This Report provides a response to the submissions made to An Bord Pleanála (the Board) in relation to the DART+ Coastal North Project.

Figure 6 – Schematic showing Proposed Turnback at Malahide

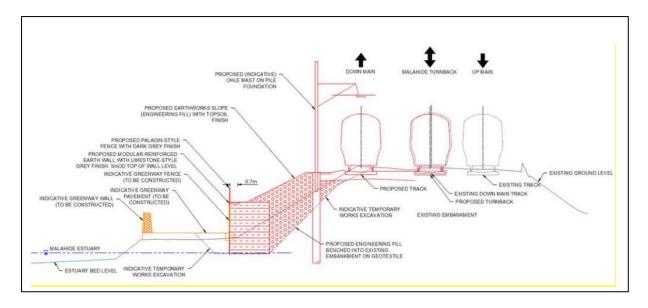
As detailed under Section 2.3.3 above, changes were made to the proposed turnback, to address the significant concern and feedback from Malahide Marina residents with respect to the original preferred option in this location. In direct response to feedback received as part of, and following PC2, where concern had been raised about potential impacts on visual amenity, light, noise and vibration and construction effects, the Applicant moved the location

of the turnback from the east of the railway line to the western side of the Southern Causeway, further away from the Malahide Marina area, see figure below.

Figure 7 – Extract from Drawings in Non-Technical Summary illustrating proposed OHLE works north of Malahide Viaduct

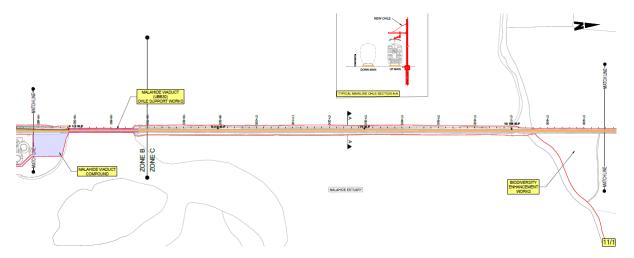
road or reverse out of the haul road. Therefore, there needs to be adequate space for the vehicles to turn without significant traffic management impacting on the public on Bisset's Strand. The Applicant therefore is not in a position to change this requirement, and it is requested that the requirements as set out in the Railway Order application are included in any permission.

c) The Applicant notes that the agreement for the proposed OHLE masts on the northern causeway to be located on the east side of the railway and cantilever over the railway is reflected on the Non-technical summary drawing 11/2, extract shown below. The Applicant therefore has no objection to this proposal being conditioned by An Bord Pleanála, should it grant the Railway Order.

Figure 10 - Excerpt from Railway Order Application Work Plan 01

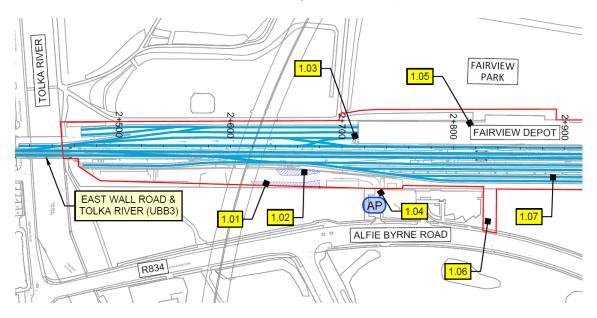
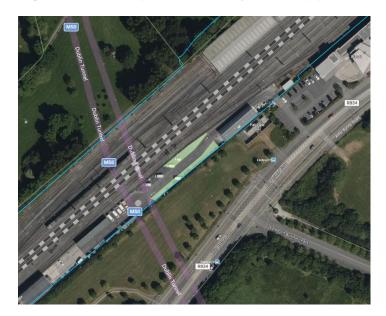
As detailed in the Railway Order application (see in particular the First Schedule, Sheet No. 1 Clontarf Road Station and Surrounds and Book 1 Railway Works Plans - Works Plan 01), the nearest permanent works to the Dublin Port Tunnel (DPT) are those detailed under 1.03 within Sheet No.1, being: "Minor works external to Fairview Depot Maintenance Building including new track pans for train cleaning, walkways and low-level lighting."

The location of these compounds is shown in the Works Plans (Work Plan 01) in the Railway Order application, an excerpt of which is provided below. The Dublin Port Tunnel is shown traversing the site at approx. chainage 2+620 on the work plan excerpt below. It is clear that one of the temporary compounds, CC-2650 (shown on extract as 1.01), slightly overlaps the DPT in this location. No excavation works are proposed for either compound in this location, as the compounds are located on an existing surfaced car park area, see below:

Figure 14 – Excerpt from Property Plan 15

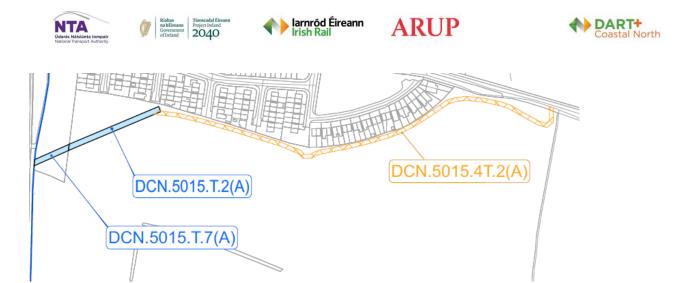
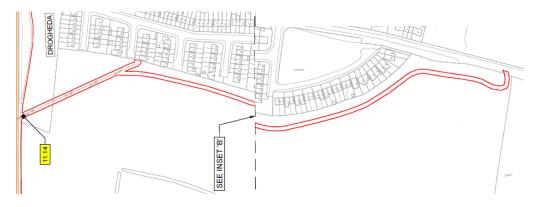
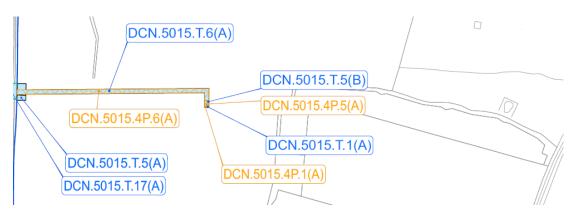
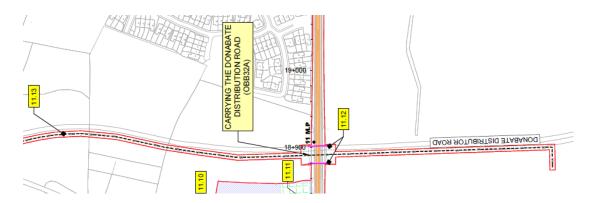
Schedules DCN.5015.T.7(A), DCN.5015.T.2(A), and DCN.5015.4T.2(A) relate solely to the decommissioning and removal of the existing overhead MV power line, with no future works or access requirements anticipated (referenced as 11.14 on Works Layout Plan 11/2) once the works are complete. These works are essential to support railway electrification. Extracts from Property Plan 15 and Works Layout Plan 11/2 are provided below.

Having further investigated (see the image below), the Applicant now confirms that the proposed connection to the existing ESB network is located outside lands under Cairn Homes' control. As a result, the referencing of Schedules DCN.5015.T1(A) and DCN.5015.4P.1(A) was incorrect, and should not have included the applied buffer zone slightly overlapping with Cairn Homes' lands. The Applicant agrees to remove these schedules and proposes to correct this error in the Book of References – Schedule 1.

Figure 19 – Excerpt from Schedule DCN.5015.PA.1(A)

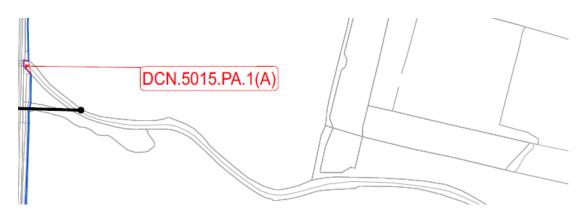
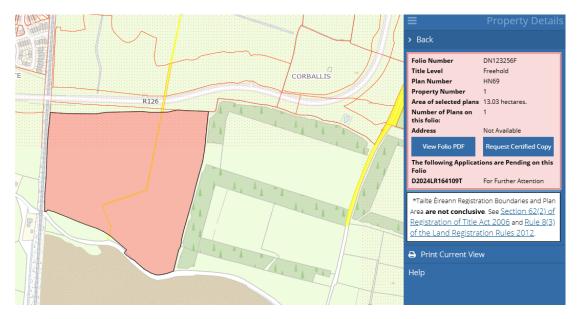
Schedule DCN.5015.PA.1(A) is required to acquire airspace necessary for the overhead line equipment (OHLE) wire. The Applicant has verified the boundaries for LPID 331 on Land Direct, confirming their accuracy, as shown below.

It is acknowledged that ownership of the land associated with Schedule DCN.5015.PA.1(A) (airspace for the OHLE wire) has been transferred to Fingal County Council. Further discussions between Fingal County Council and the DART+ Coastal North team will be arranged to agree on the proposals for this location.

Figure 23 – Diversion Routes during Construction

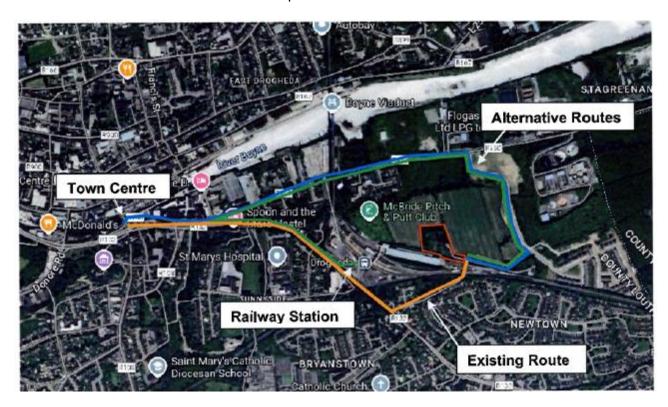
This results in several sustained negative impacts to our client's daily life for a period of at least 3 years and significantly constrains access to family, neighbours and everyday facilities and amenities on Dublin Road including shops, medical facilities, church, public transport etc. and limit potential for social engagement.

it is respectfully requested that our client be permitted to access Dublin Road via the existing Irish Rail maintenance depot entrance from McGrath's Lane and route through the railway station for the duration of the construction phase.

Figure 24 – Extract showing distance of Proposed Substation and Depot relative to Chanticleer Property

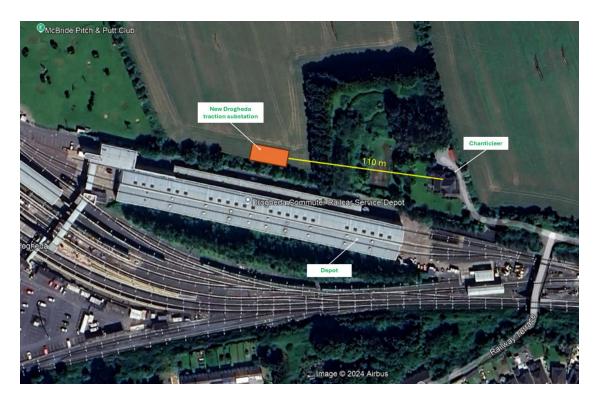
Chapter 22 references that the local residents and community, among others, are potentially sensitive receptors for EMFs and includes a detailed assessment of the potential for significant effects on these receptors.

At the outset of this study, a categorisation of receptors in respect of sensitivity was undertaken, as detailed in Table 22-5 of Chapter 22 of the EIAR, where residential areas (not containing specific medical equipment) are considered to have a low baseline rating, meaning that it is normally not expected that these areas are affected by EMFs produced by substations. This is corroborated by the fact that there is an existing operational 10 kV substation in proximity to the property at Chanticleer, in the Drogheda depot building (the depot building being closer to the location than the new traction substation at Drogheda will be located, approximately 110 m away from Chanticleer).

Figure 25 – Excerpt from Section 15 of the EIAR, Figure 15.3 Landscape Mitigation for Drogheda MacBride Station and Surrounds

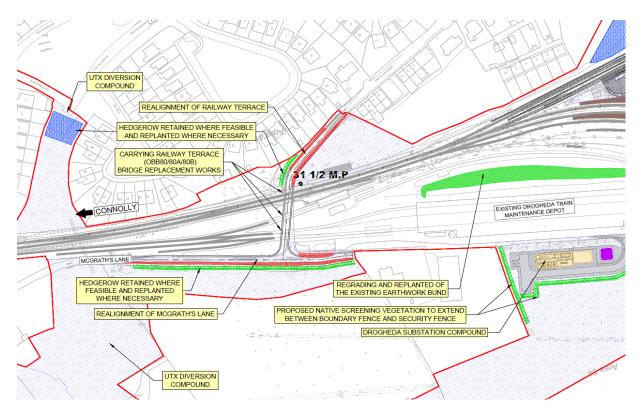
The submission notes that the submitted drawing OBB80C – McGrath's Lane Overbridge Site Location Plan appears to suggest that a two-way road will be implemented extending to the entrance gates of our client's property, with no indication of landscaping or planting on either side of the road. This is not acceptable to our client who currently enjoys an established and attractive welcome to his home on the approach from the railway bridge, as shown below.

Mitigation measures for retention and protection of existing trees and vegetation, where possible during construction are specified in Section 15.6.2 of Chapter 15 of the EIAR. Mitigation measures for replanting – to match existing and/or use native species are specified in Section 15.6.3 of Chapter 15 of the EIAR. Refer to Figure 15.3 Landscape Mitigation for Drogheda MacBride Station and Surrounds, which details that the existing hedgerow is to be retained where feasible and replanted where necessary along the northern boundary of McGrath's Lane. See extract below.

Figure 26 – Alternative Bridge Reconstruction Proposal from Submission SB0076

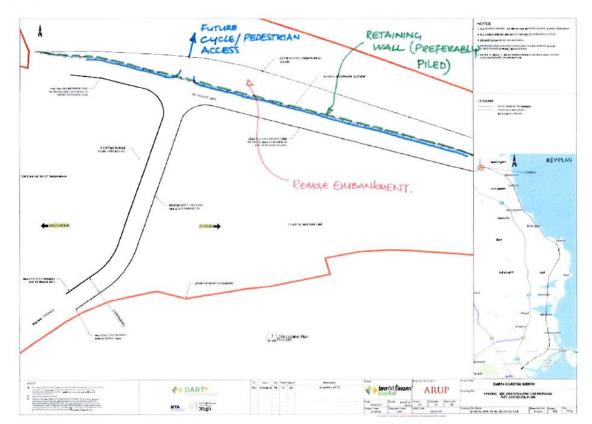
The submission notes that the reconstruction of McGrath's Lane Overbridge would unnecessarily acquire prime urban land, and the proposed embankments could be replaced with retaining walls to reduce the land impact. Extract below showing Murphys alternative

Figure 28 – Excerpt from SB0038: Suggested Provisions for Future Pedestrian / Cycle Link to MacBride Station

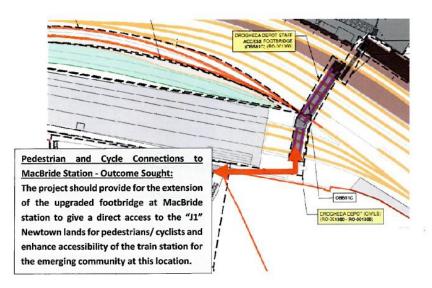
The submission calls for enhanced pedestrian and cycling connections to Drogheda MacBride Station, particularly through an upgraded footbridge that integrates better with future development plans.

Figure 29 - Alternative Bridge Reconstruction Proposal from Submission SB0134

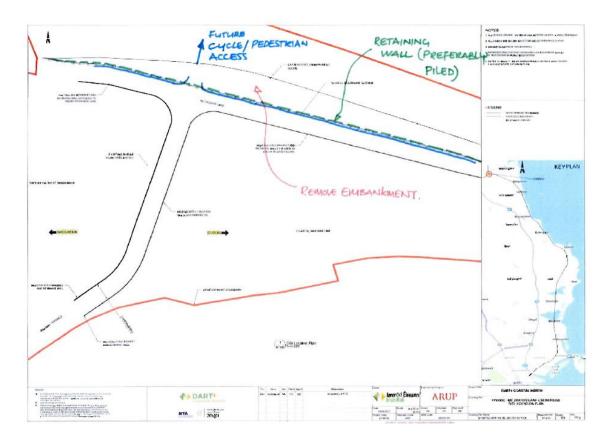
The submission notes that the reconstruction of McGrath's Lane Overbridge would unnecessarily acquire prime urban land, and the proposed embankments could be replaced with retaining walls to reduce the land impact. Extract below showing Murphys alternative proposal.

Figure 31 - Excerpt from Submission 0134: Suggested Provisions for Future Pedestrian / Cycle Link to MacBride Station

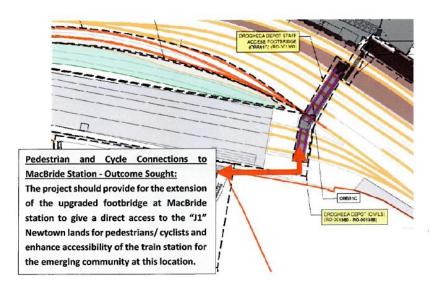
The submission calls for enhanced pedestrian and cycling connections to Drogheda MacBride Station, particularly through an upgraded footbridge that integrates better with future development plans.

Figure 32 - Figure 1: Extract from Works Layout Plan No. 10 Malahide Station and Surrounds from SB0154

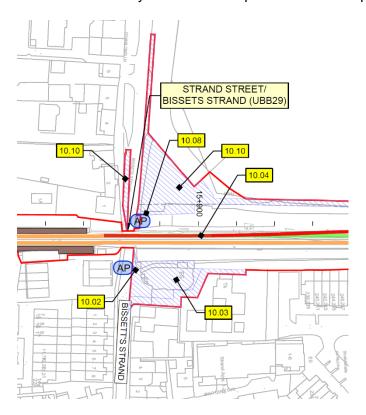
The submission notes concern in relation to the inclusion of areas along the northern side of Bisset's Strand, used by residents for parking and bin collection. The submission notes provision for alternative arrangements are not included in the DART+ Coastal North Proposals. The concerns relate to the proposed construction compound referred to by reference 10.10 on Works Layout Plan No. 10 Malahide Station and Surrounds, in figure 1 below.

The submission notes that the area in question is used by 7 houses for regular bin collection, and the parking spaces are used by residents of the Strand, commuters availing of Malahide Station and Shoppers in the Malahide area. The submission notes that alternative permit parking is not available to the residents who rely on these parking spaces, and that existing parking spaces on the sea-side of Bisset Strand are also included within the extents of the construction compound and will not be available to residents for the duration of the construction works.

As part of the ongoing Broadmeadow Way construction works, 4 new residents parking spaces are being provided. The submission queries what will happen to the spaces when the Broadmeadow Way works are completed in 2026 as planned.
